Planning Committee Meeting  
Open Portion  
Wednesday, 11 October 2023  
at 5:00 pm  
Council Chamber, Town Hall

**APPLICATION UNDER HOBART INTERIM PLANNING SCHEME 2015**

- 1.1 Planning approval is sought for Partial Demolition, Alterations, Extension, Front Fencing, and Alterations to Carparking, at 250 Macquarie Street, Hobart.

PROPOSED SITE PARKING PLAN

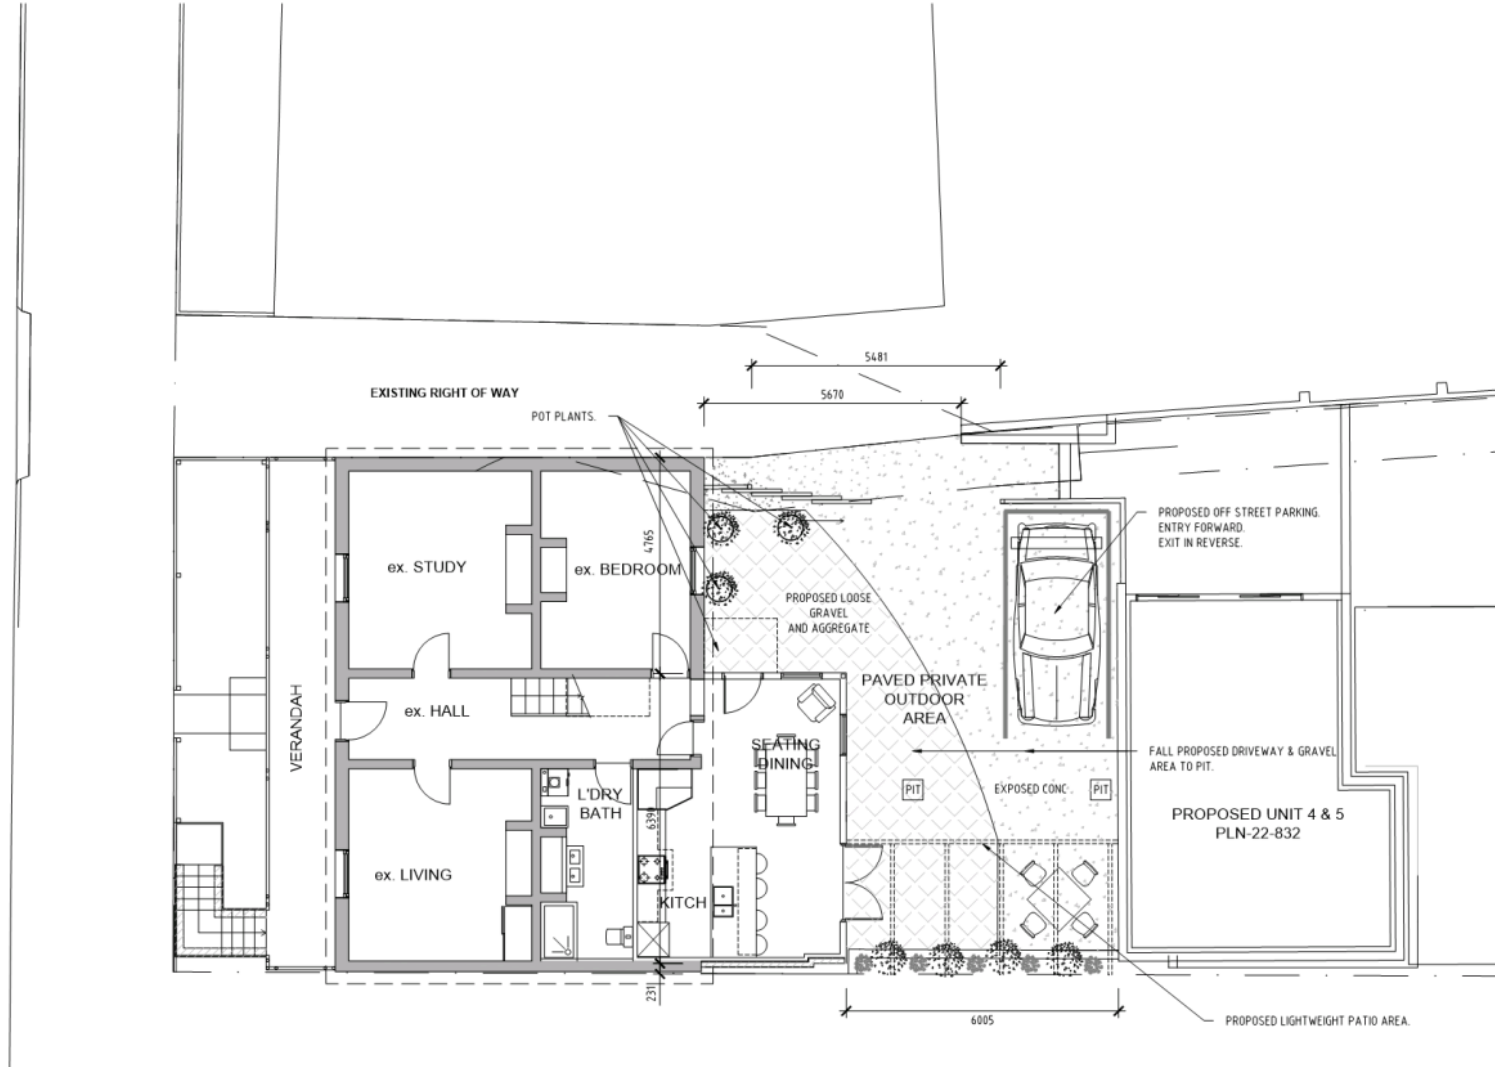
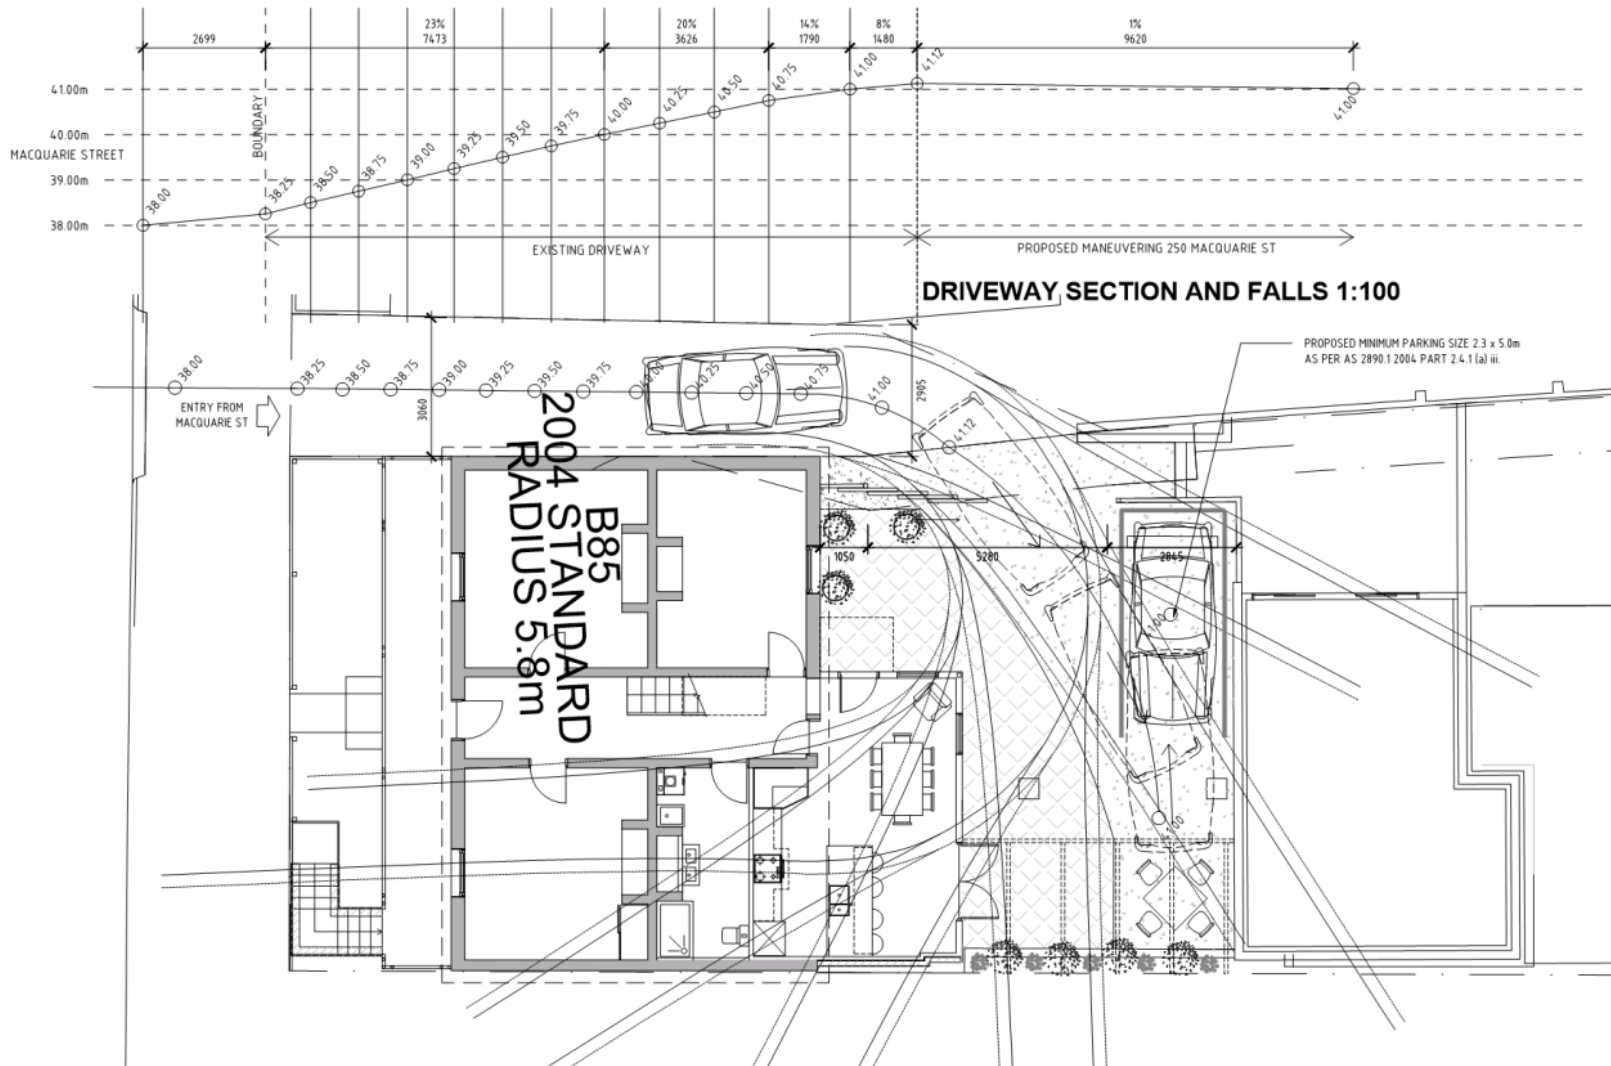
The design of the vehicle access point is not safe, efficient, or convenient. The documentation provided does not satisfy the Performance Criteria P1:E6.7.2 of the Planning Scheme. Given the impeded sight distances, high traffic volume, and inability to access the parking area due to the access constraints.

**The parking space proposed is below the minimum width and length. A blind aisle extension is not incorporated into the design, and in combination with the 3m aisle width the parking layout does not allow for a car to access the parking space as proposed. The width of the driveway (2650mm) is below the minimum Australian Standard (3000mm), and restricts access to the parking area. Swept paths below show vehicles unable to enter the parking area, coming into contact with the fixed building walls of 248 Macquarie and 250 Macquarie. The parking layout proposed is not functional, and the submitted documentation does not meet the Performance Criteria P1:E6.7.5.**

**Attachment A: Dimensioned plan showing inconsistencies.**

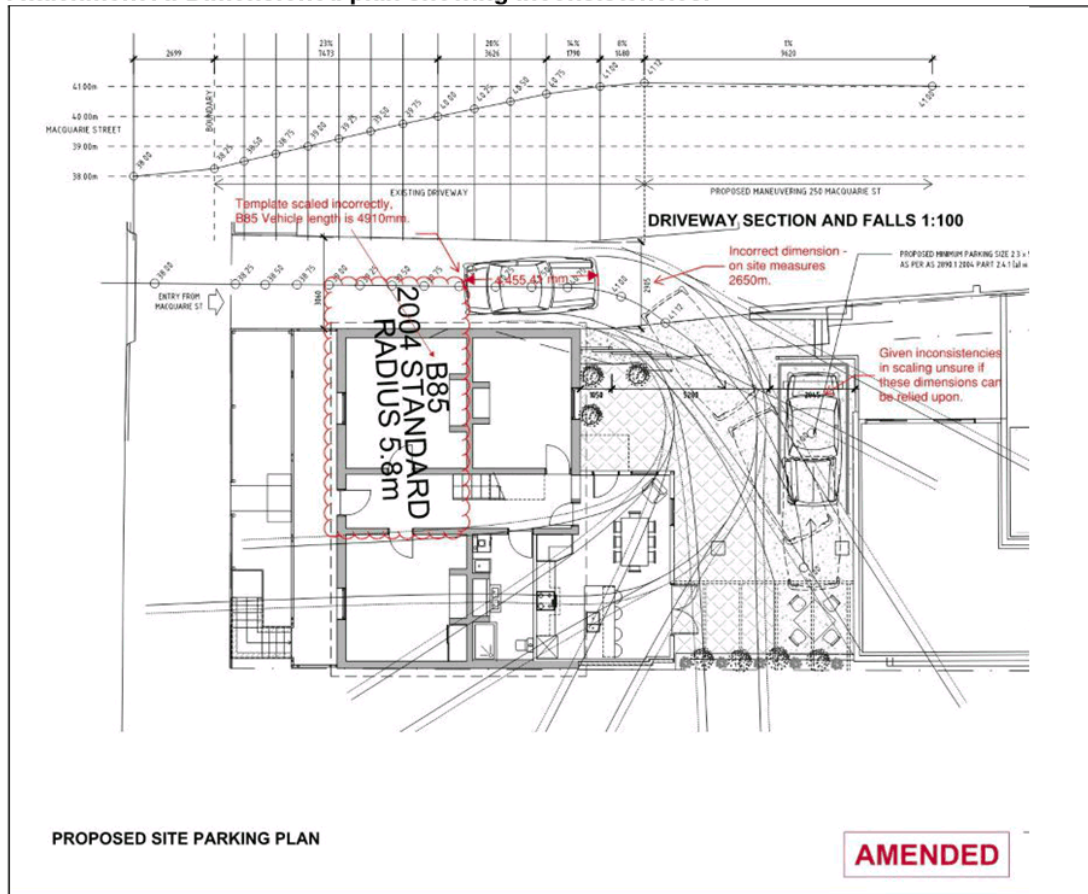
Inconsistencies are present in the documentation provided by Design.EAST Pty. LTD. The minimum width of the access was initially detailed as 2750mm in the original plans submitted on the 20th of December 2022. After the initial request for information, amended plans were submitted by Design.EAST Pty. LTD on the 9th of February 2023. That submitted documentation detailed the minimum width as 2905mm. On-site measurements found this distance to be 2650mm (see attachment B and C), which does not align to the design drawings provided. This dimension governs the scaling of the drawings, and hence by changing this dimension it appears as if a vehicle of a normal size could access the parking area. However, this is not actually the case. Note that as part of the discussions that occurred between the applicant and officers after advertising had occurred, revised plans were submitted (in September this year) showing the correct dimension. The corrected plans also do not satisfy the Parking and Access Code.

Development engineering is not supportive of the proposal on the grounds that the submitted documentation fails to comply with the performance criteria for:

- E6.7.2: Design of Vehicle Access P1
- E6.7.3: Vehicle Passing area along an access P1
- E6.7.5: Layout of Parking P1
- E6.7.6: Surface treatment of parking areas P1

Refusal of the application is based on the safety risk that the design proposes. Exiting vehicles will have no sight distances for pedestrians and are required to reverse over the footpath with

Attachment D: Dimensioned plan showing true scale.

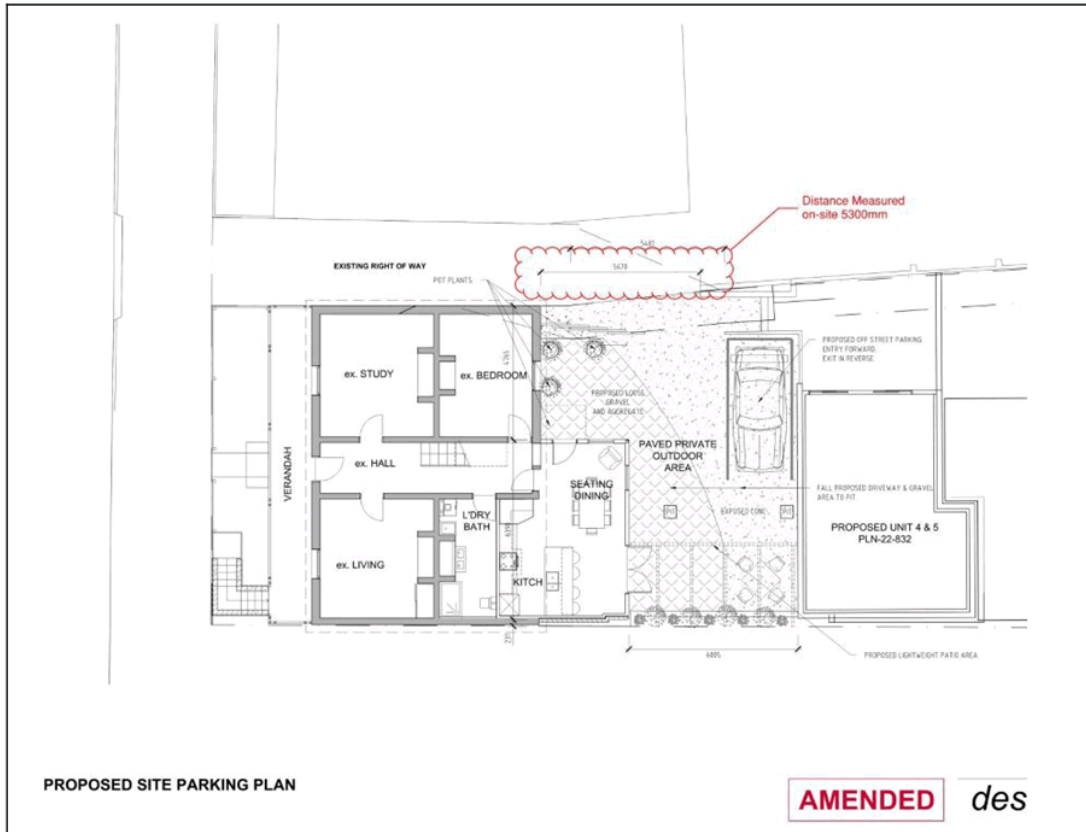
Attachment E and F: Images confirming access width as 5300mm not 5670mm

**Attachment G: B85 Vehicle Turn path (averaged size car for example a Toyota Camry) showing conflict with fixed objects on entry. Vehicle is unable to enter the car parking space as proposed.**

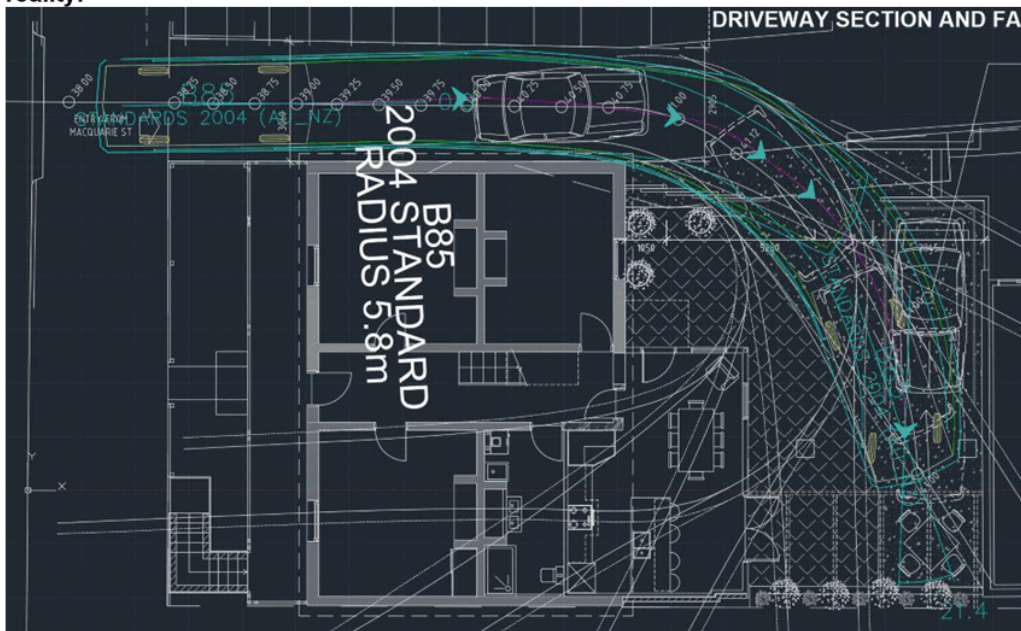
**Note yellow line is the computer simulation, and the blue is what is likely to occur in reality.**
